LOST CREEK IV MASTER DEVELOPMENT PLAN

City of San Antonio
Development Services Department
Master Development Plan
REQUEST FOR REVIEW

The City Staff Development Review Committee has reviewed Lost Creek IV Subdivision Master Development Plan M.D.P. # 829. Please find enclosed a signed copy for your files. Your plan was accepted, however please note the following:

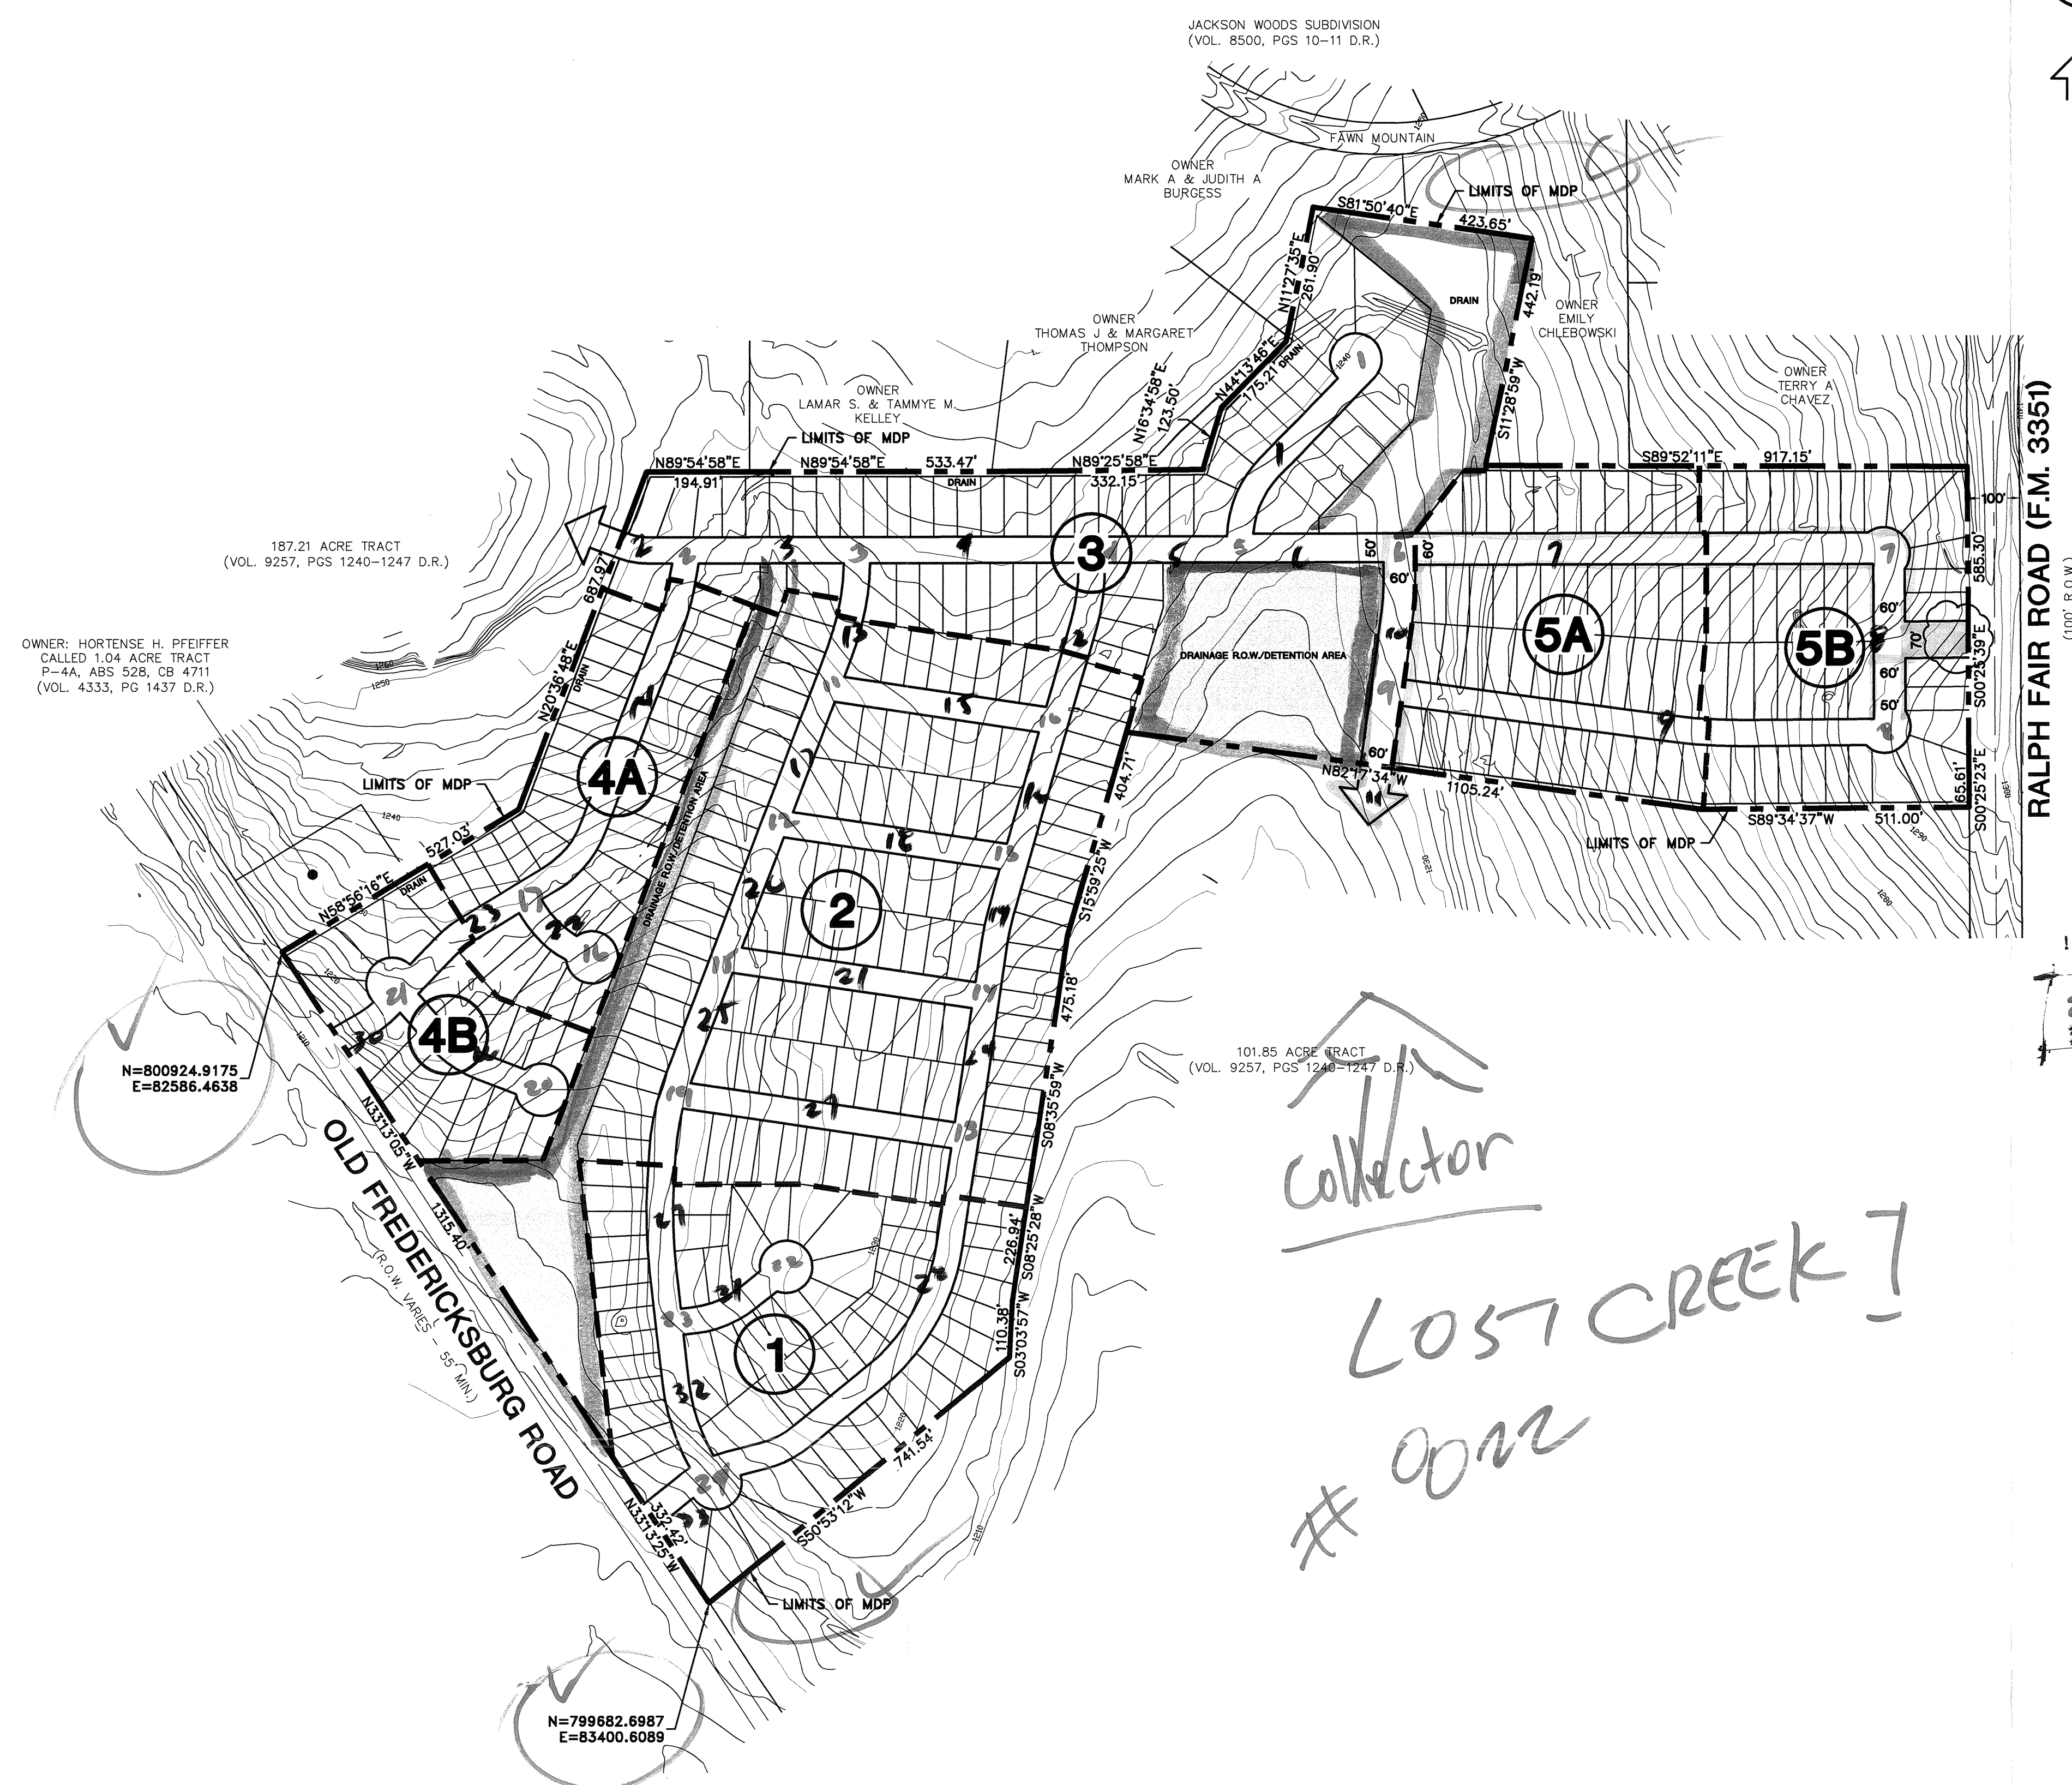
1) PROVIDE COLLECTION SECTION FOR ACCESS INTO RALPH FAIR
MINIMUM ONE LOT DEPTH.
2) DO NOT SIDE RESIDENTIAL LOTS AGAINST OLD
FREDERICKSBURG.

4) NOTES: ADD OR "LATEST VERSION OF" BEHIND 2001 EDITION

1. Based upon the information provided, the above referenced MDP is approved with the following conditions:
 - a. Provide pavement transition from the Local Type B off Ralph Fair Road to the respective Local Type A.
 - b. In Note 5, change the reference to UDC Section 35-506(d)(5).
 - c. It appears that three(3) cul-de-sacs in Unit 2 are greater than 500 feet in length, so they will require turnaround rights-of-way of 120 feet in diameter.
2. It should be understood that this is a general review of a conceptual plan and that ***all*** technical requirements of the Unified Development Code for Streets & Drainage shall be complied with.

A note on the master plan states that Centex Homes, the developer/owner of the Lost Creek Subdivision will once again not provide parkland, and has instead opted to pay a fee in lieu of parkland. This fee is to be determined and paid at time of platting.
